SEWAGE DISPOSAL TESTING

HOWARD COUNTY HEALTH DEPARTMENT  
ENVIRONMENTAL HEALTH SERVICES

PROPERTY OWNER CHARLES A. HOBBS, IV

RE: Hobbs Property - Lot 1

SOIL PROFILE

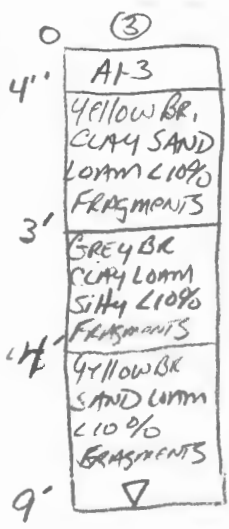
DATE	TEST NO.	DEPTH	PRE-WET		TEST - 1" DROP		TIME	
			START	STOP	START	STOP		
9/30	1 S	3.5'	10:33	10:45	10:45	11:02	17min	
	1 M	5'	10:33	10:48	10:48	11:15	27min	
	1 V	8.5'	WATER AT 8.5' - See Profile VARYING STRUCTURE					
	2 S	3'	10:36	10:42	10:42	10:52	10min	
	2 M	4.5'	10:36	10:52	10:52	11:20	28min	
	2 V	9'	WATER AT 9' - see Profile VARYING STRUCTURE					
	3 S	3'	11:24	11:31	11:31	11:46	15MINUTES	
	3 M	5'	11:24	11:35	11:35	11:53	18MINUTES	
	3 V	8'	WATER AT 8' SEE PROFILE					
	4 S	3'	11:05	11:09	11:09	11:22	13min	
	4 M	4.5'	11:05	11:18	11:18	11:44	26min	
	4 V	9'	WATER AT 9' see profile VARYING STRUCTURE

REMARKS HOLE 3 - Grey CLAY LAYER LESS PROMINENT. / HOLD FOR WET SEASON RETEST.
